PARTS BULLETIN

Original Issue Date: **7/97**
 Model: **60-100RZ**
 Market: **Industrial**
 Subject: **Field Exciter Assembly Correction**

Figure 1. Alternator Components

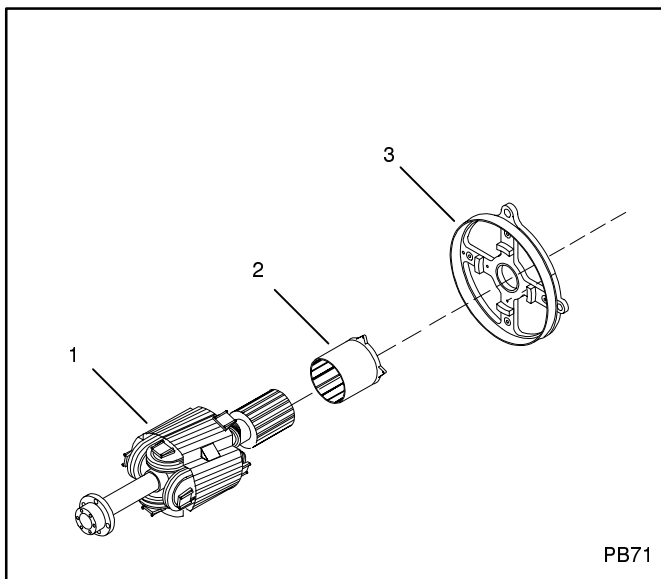
Parts Catalog TP-5614 lists the wrong field exciter assembly part number for some generator set specifications. See Figure 1 for an illustration of the field exciter assembly. Choose the correct part number from the chart below. Please make a note of the correction in Parts Catalog TP-5614 4/96, 50-100RZ, page 61, item 33.

Generator Set Specification	Field Exciter Part Number
60RZ	
187077	276657
187080	276657
70RZ	
187272	276657
187273	276657
187274	276657
187275	276657
187276	276657
187277	276657
80RZ	
187341	276657
187342	276657
187343	276657
187344	276657
187345	276657
187346	276657
100RZ	
187441	276657
187442	276657
187443	276657
187444	276657
187445	276657
187446	276657
